From: "Soham Modi" <sohammodi@modiproperties.com>
Date: 08-04-2017 6:17 PM
To: <aruna@modiproperties.com>
Attach: FBox plan 08-04-17.jpg
Subject: FW: Feeder box plan changes

From: Nilgiri Estates [mailto:nilgiriestate@modiproperties.com]
Sent: 08 04 2017 12:06
To: Soham Modi <sohammodi@modiproperties.com>
Subject: Reg: Feeder box plan changes

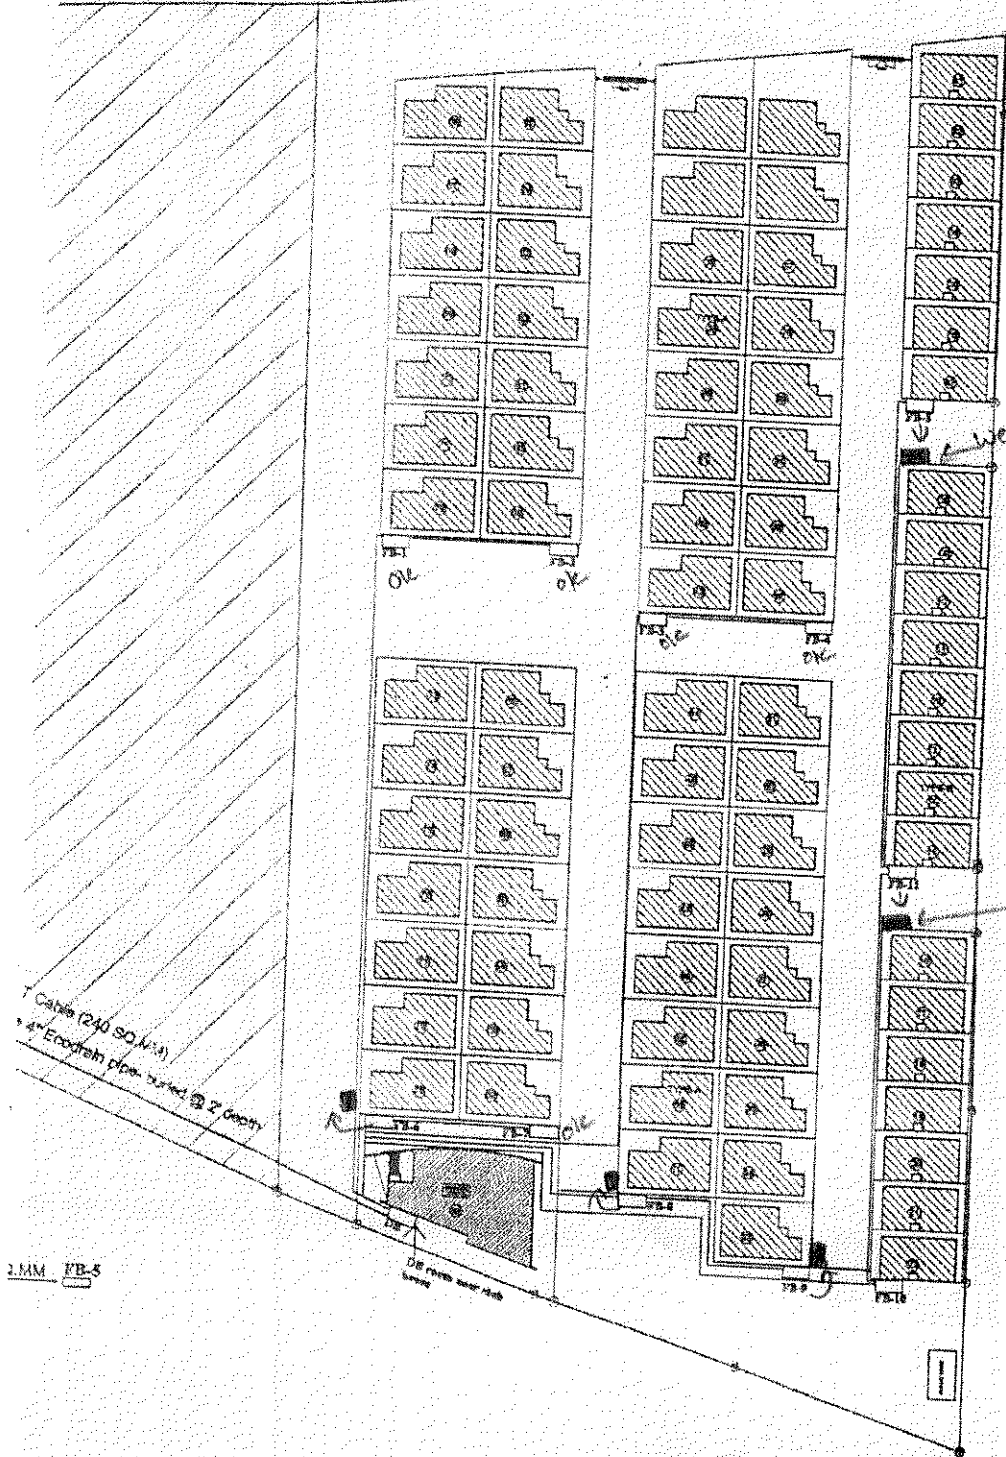
Sir,
Please find the attachment of changes made on feeder box plan. In that we need approval to shift FB-5 and FB-11 as marked in plan and we have problem in casting Column for FB-10 as we have pipeline on south side and there is a gap of 2'-7" between planter box and compound wall brick pillar on west side.

Sir,
for F.B.D we have pipeline on
South side and only 2'-24"
Gap between planter box and
Compound wall brick pillars at
west side

we need approval to shift here

we need approval to shift here
